RECODE KNOXVILLE

Charrette Report

The East Tennessee Community Design Center appreciates the opportunity to develop this report on the findings from the Recode Knoxville Design Charrette and Design Standards Roundtable Discussion.

Merchant Drive at Clinton Highway

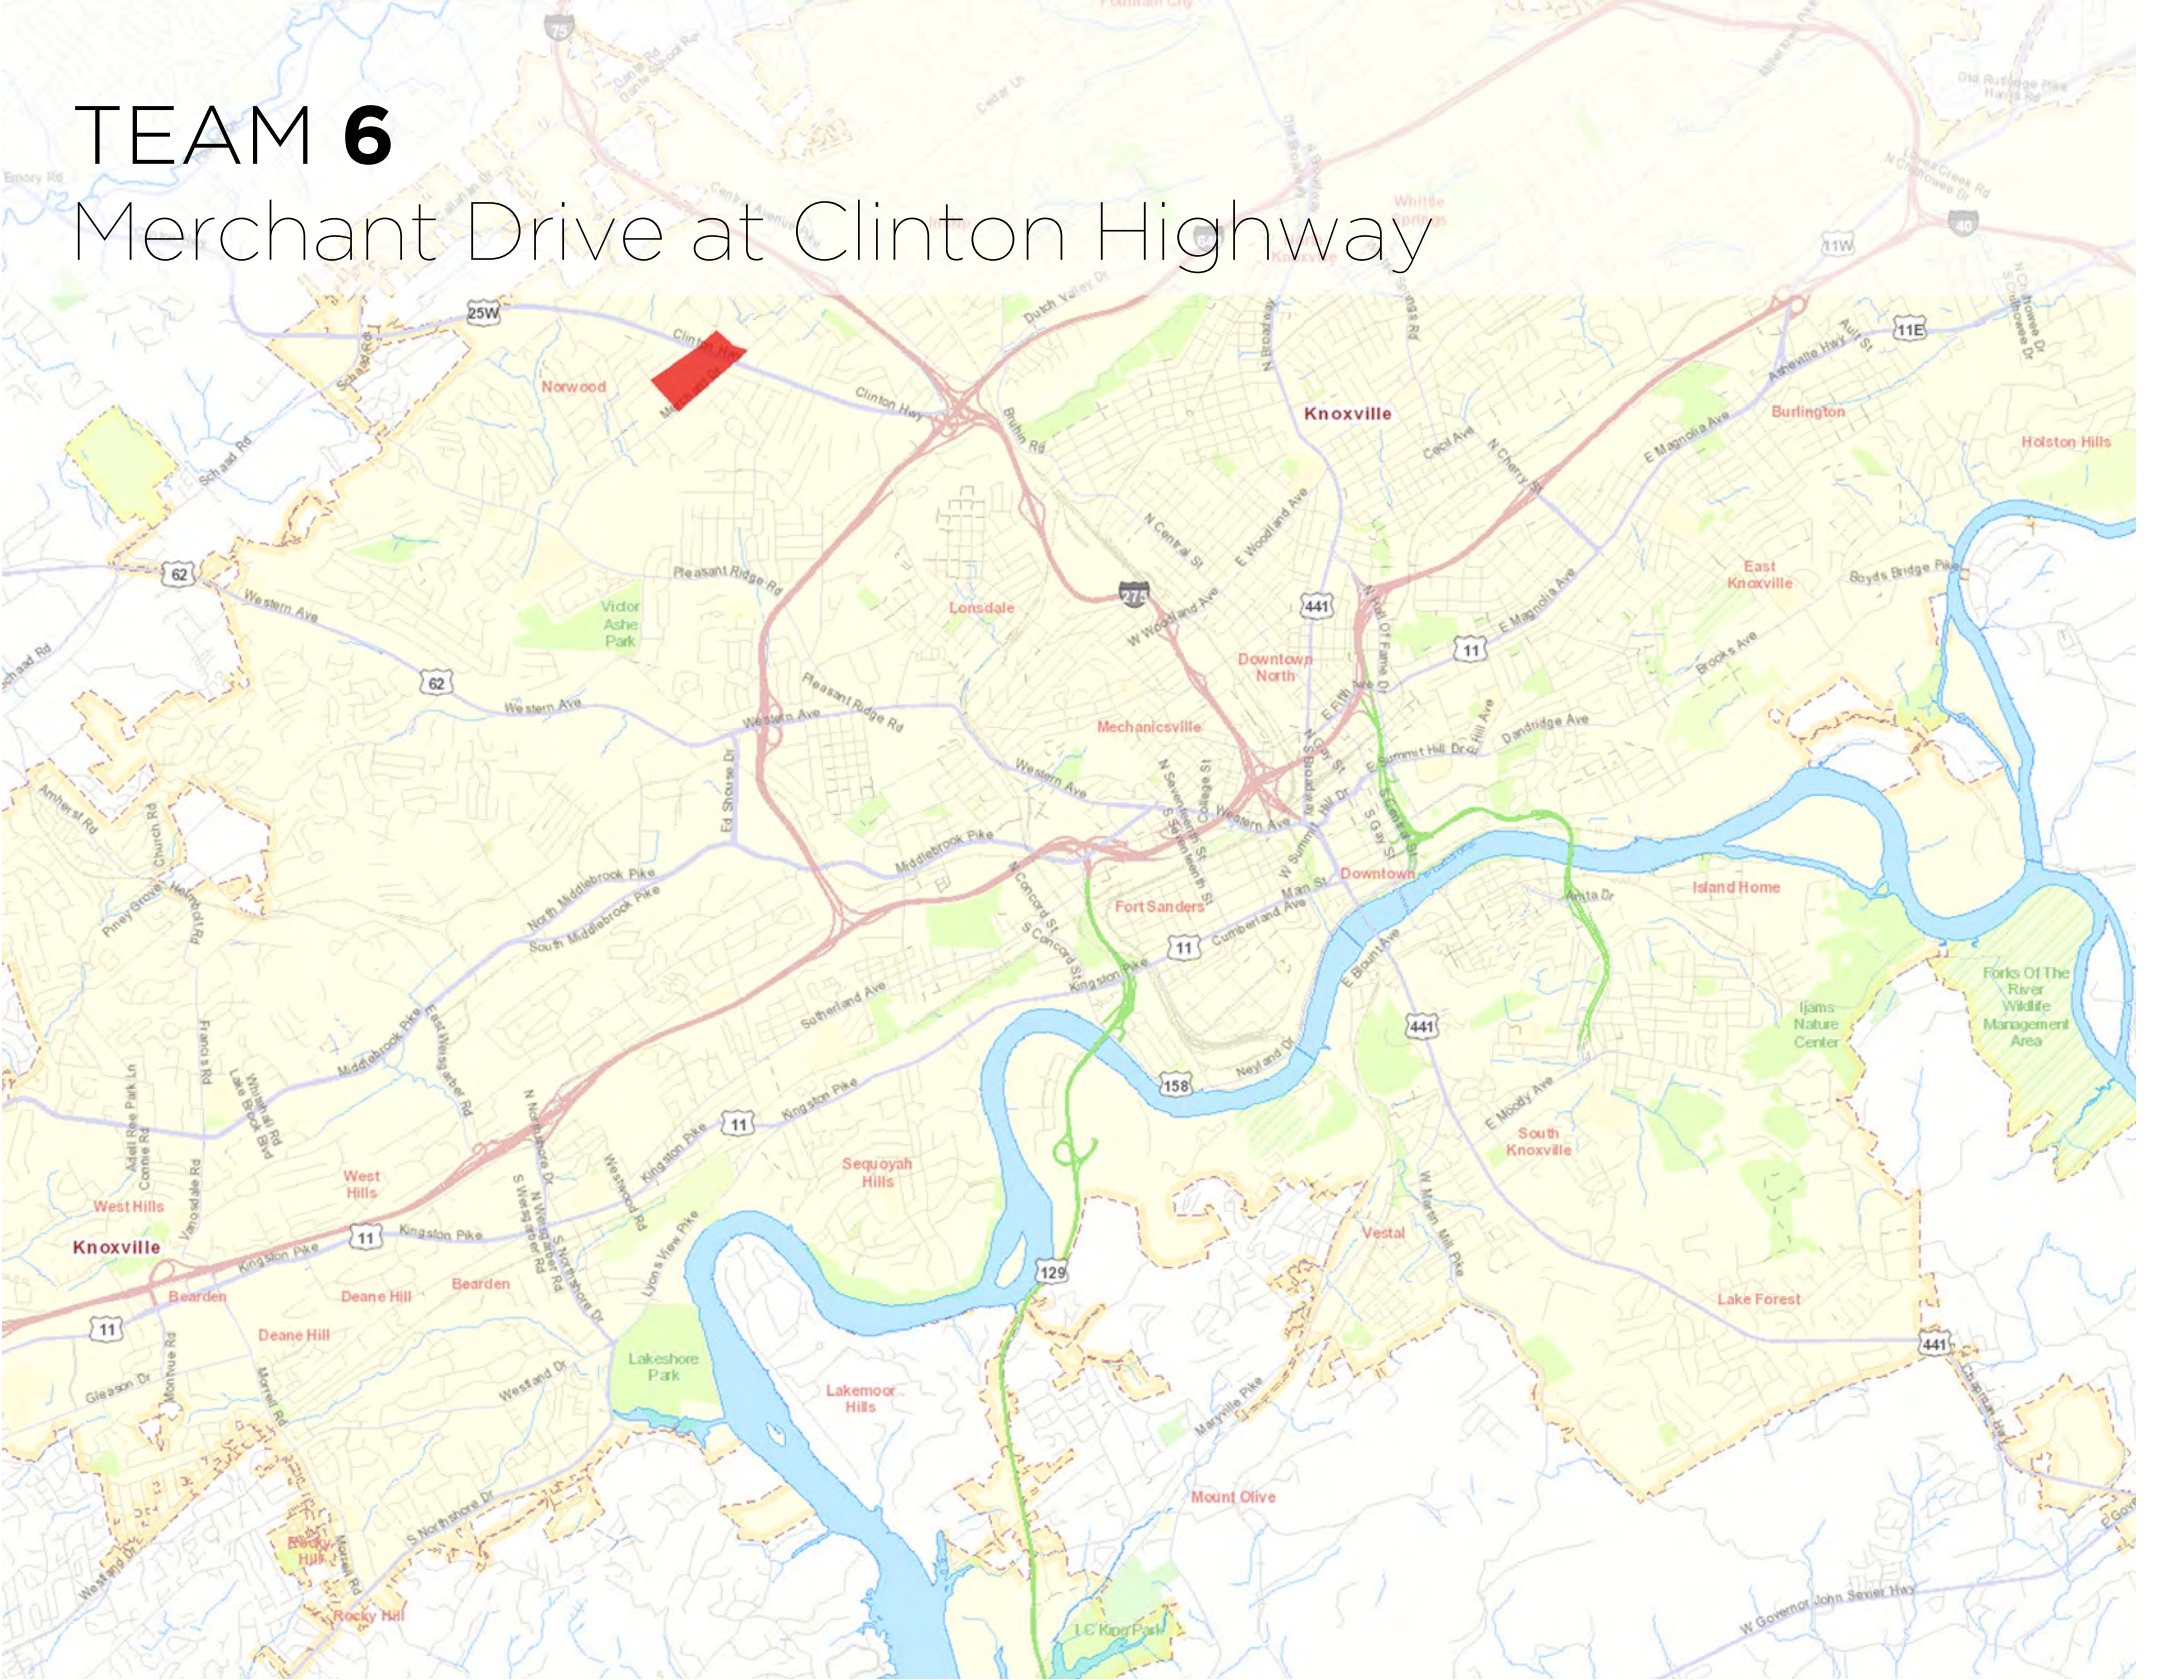
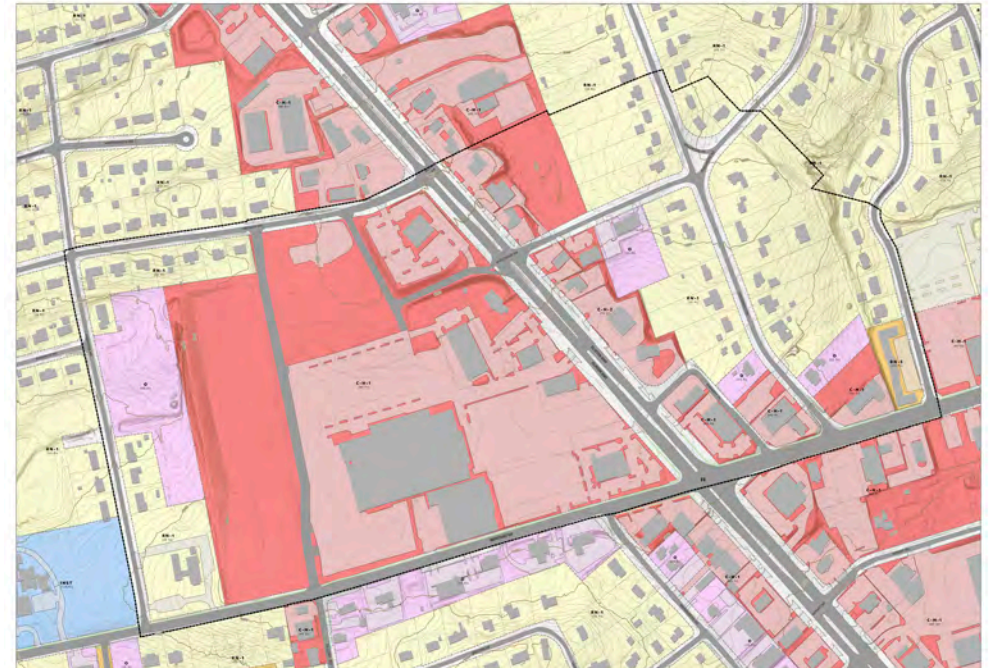
Team 6 developed the site using the ‘Town Center’ approach by creating an open public space commonly found in the heart of a traditional town used for community gatherings. Around the Town Center they developed mixed use commercial areas that transitioned to higher density residential and then to single family that currently exists at the perimeter of the site. They concentrated on improving walkability by connecting a path between existing neighborhoods and the new pedestrian-friendly development. The new center would give residents access to commercial, residential, and office space within walking and biking distance, further reducing the need for vehicular access. They felt this site could be easily developed to allow for more options of multi-model forms of transportation, including public transit.

- CH-1 allowed office use, but didn’t limit the square footage as if it was zoned strictly O. That may be a something that Knox Planning should confirm.
- CH-1 and other highway zones should address the number of and distance between entries and exits (curb cuts).
- They felt that parking was greatly reduced compared to current zoning, and still provided adequate parking spaces per SF of building.
